Zoning Staff Report

Date: June 25, 2024 Case Number: ZC-24-052 Council District: 8

Proposed Use: Automated car wash

Request: To: Add Conditional Use Permit (CUP) to allow a carwash facility in "E"

SITE PLAN CARWASH LOIS STREET & VAUGHN BLVD

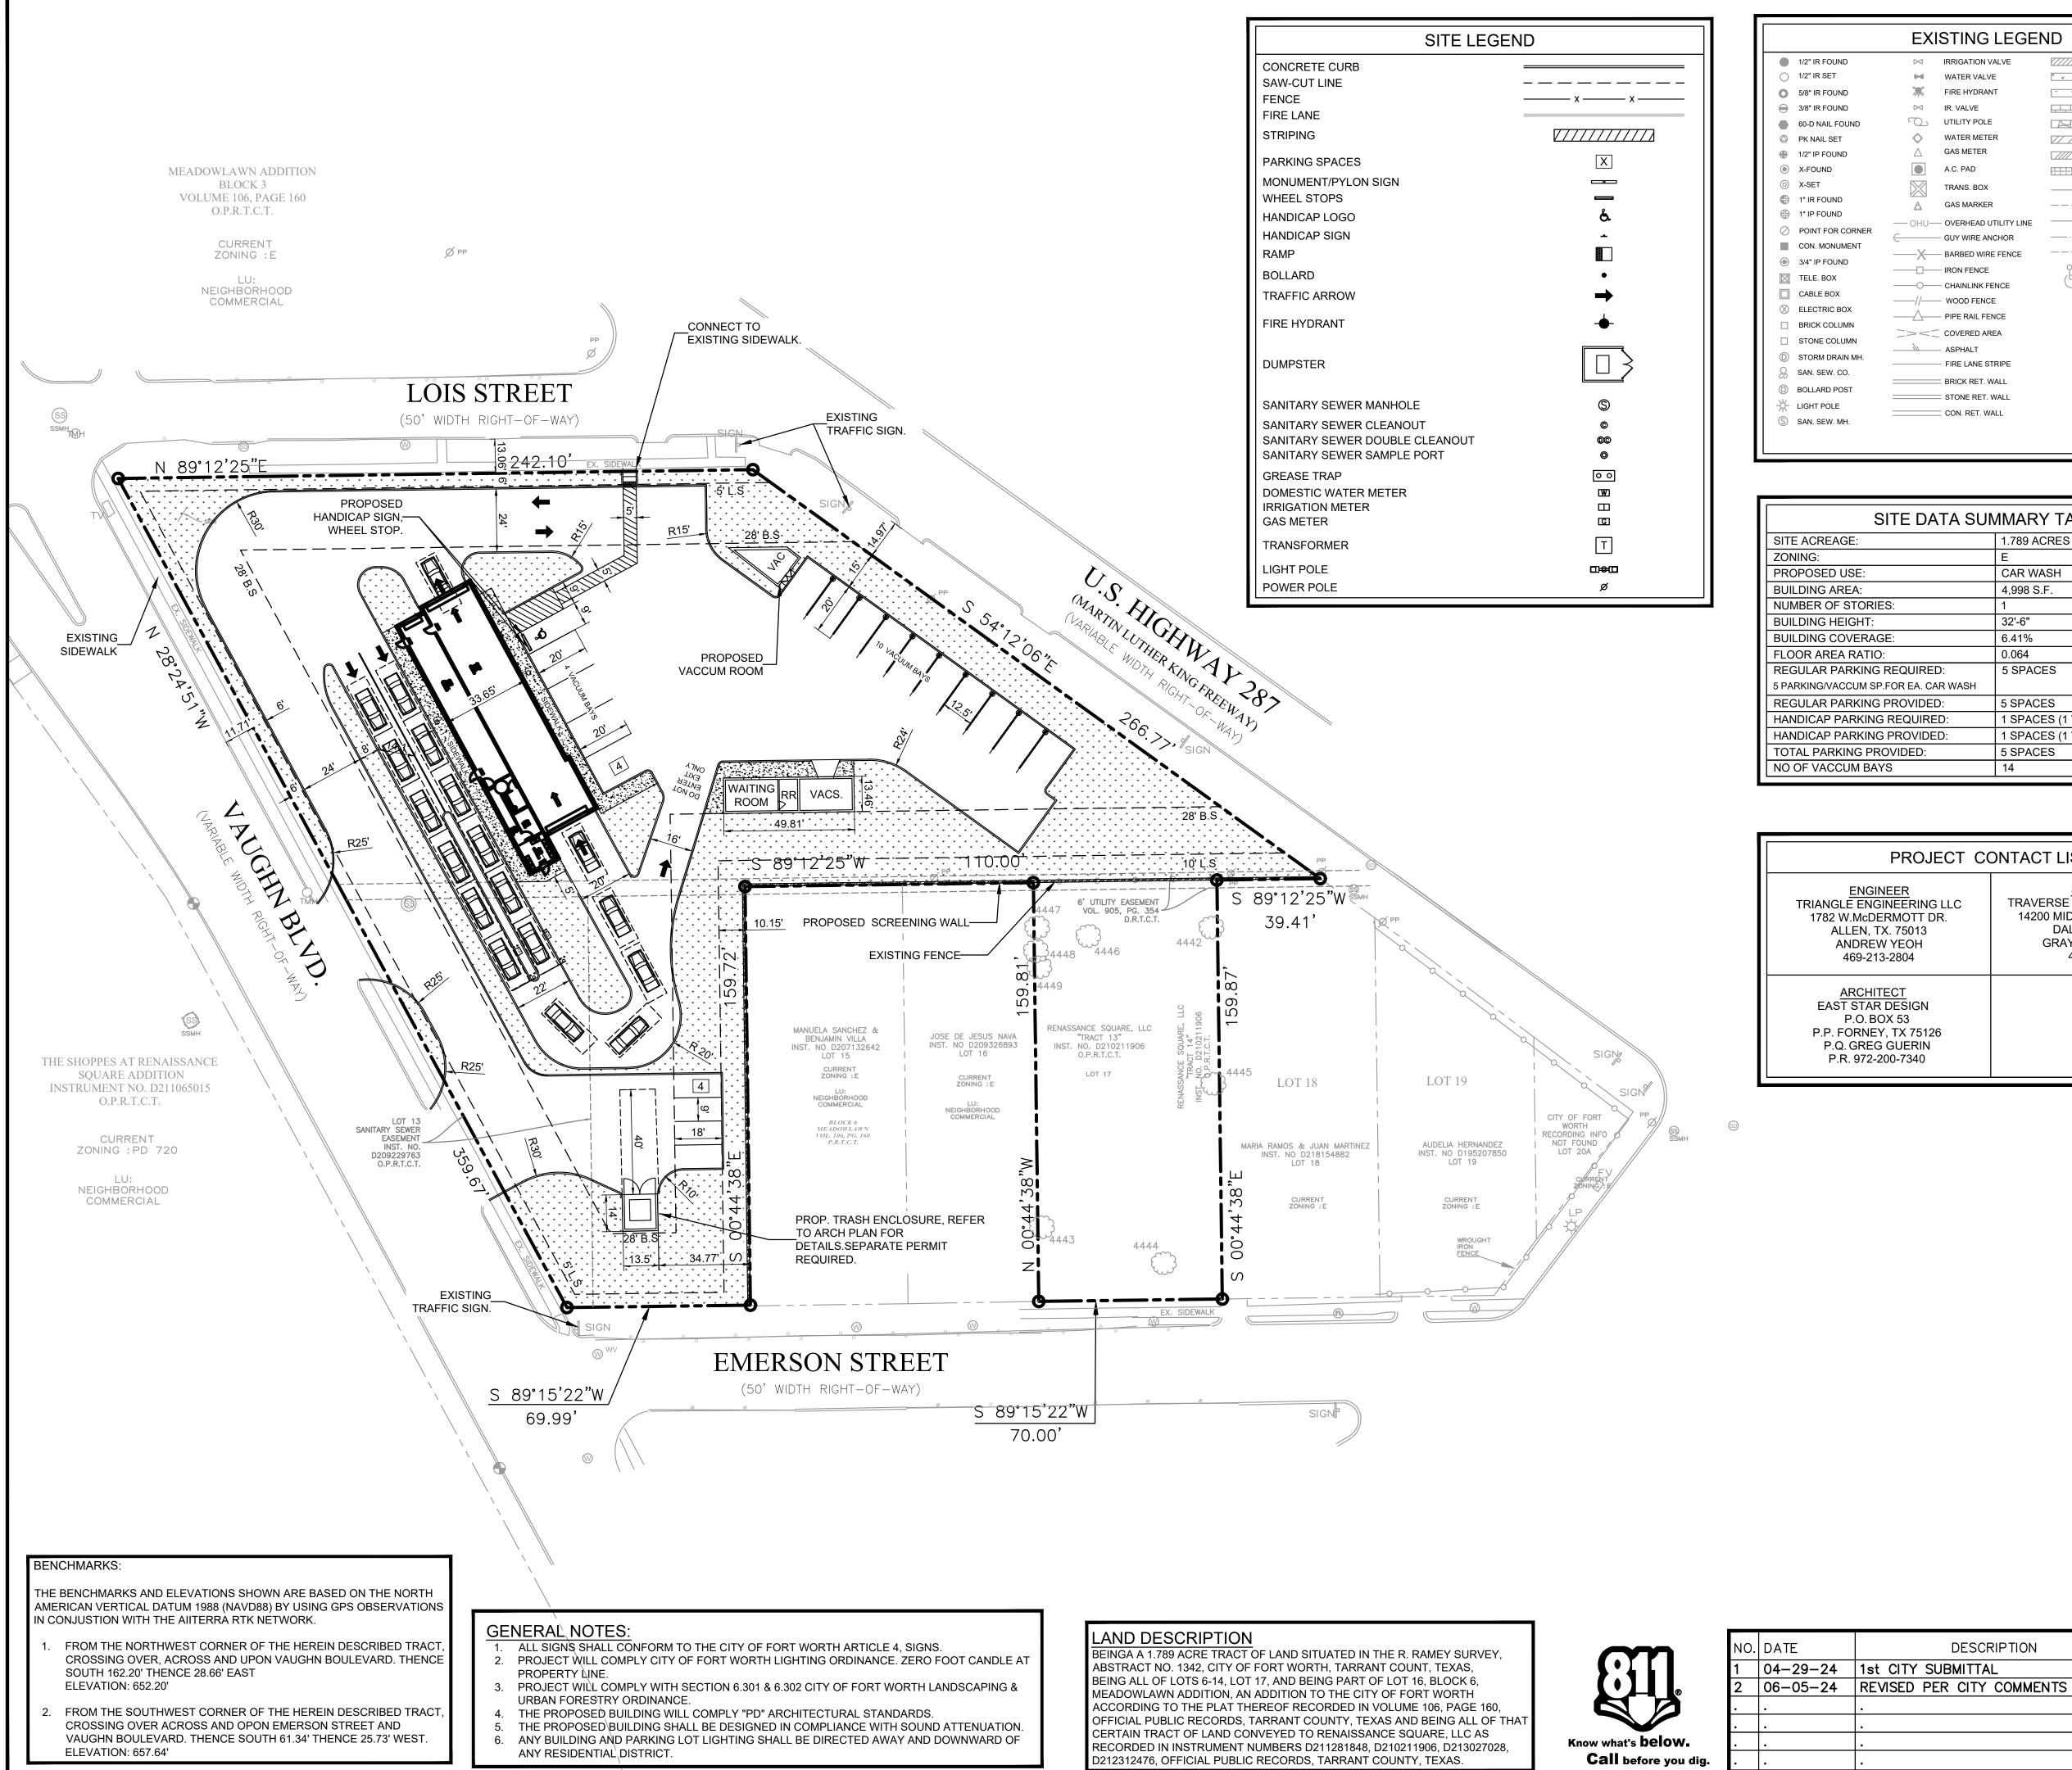
The submitted site plan is in general compliance with Zoning Ordinance regulations.

- 1. Provide elevations, screening and any enhanced landscaping
- 2. Dumpster adjacent residential uses?
- 3. Provide items from application checklist
